Amendments to the Drawings

N1272-00900

Figure 2

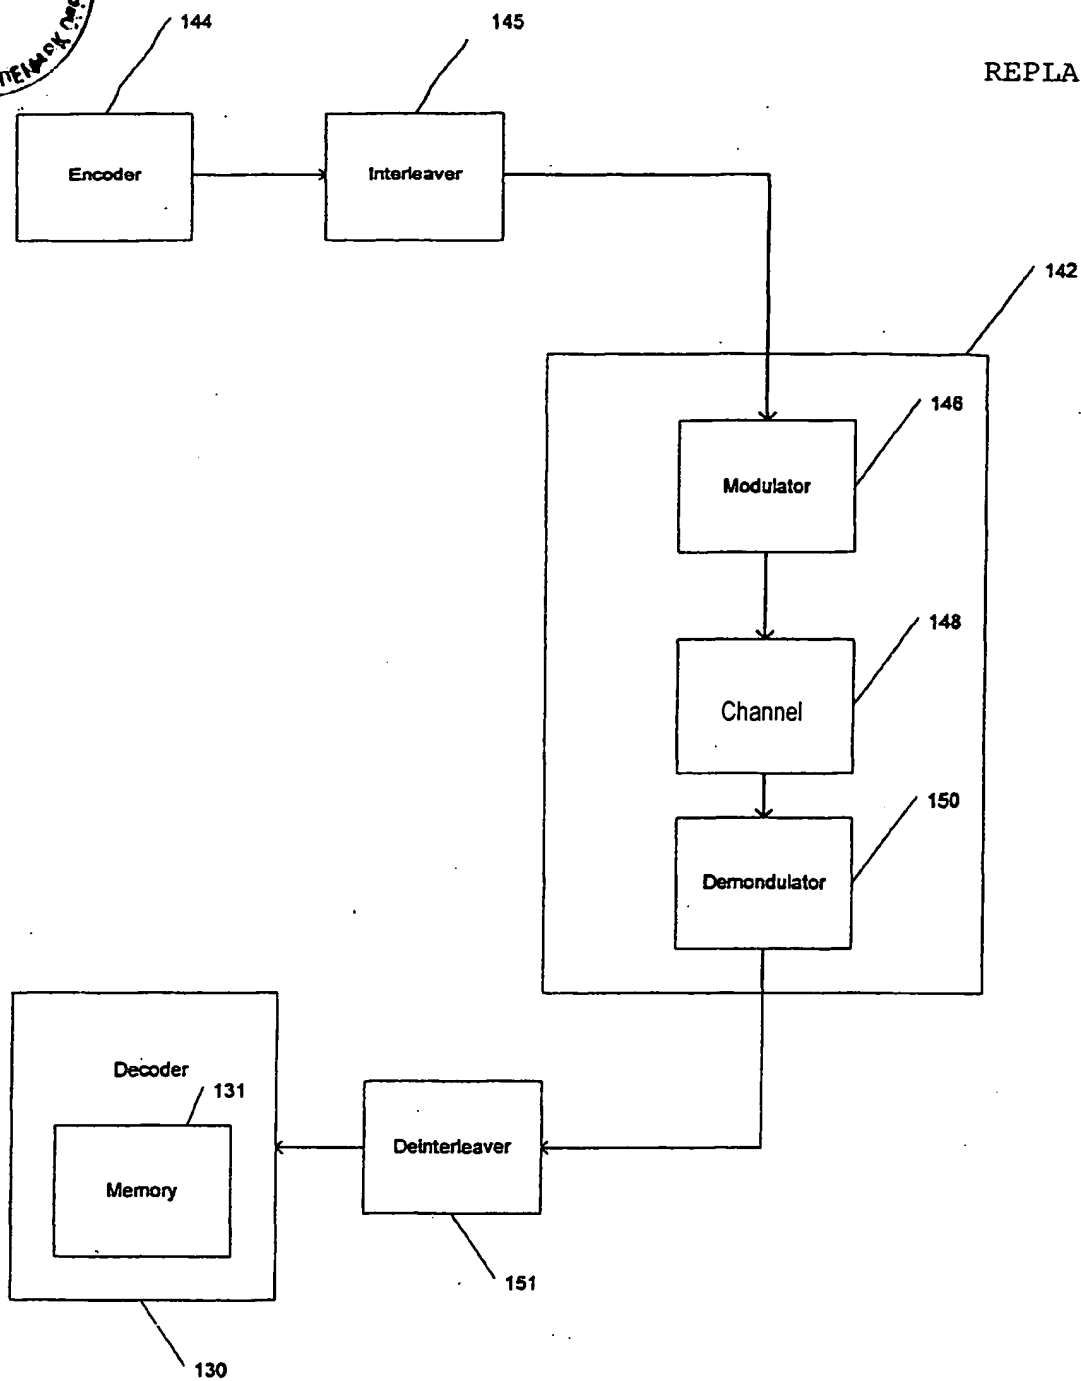
Two Replacement Sheets of Drawings are attached hereto. These sheets include Fig. 2 which has been amended to add a missing descriptive label as required by the Examiner. Fig. 4 is newly added to cover features of claim 7, as suggested by the Examiner.
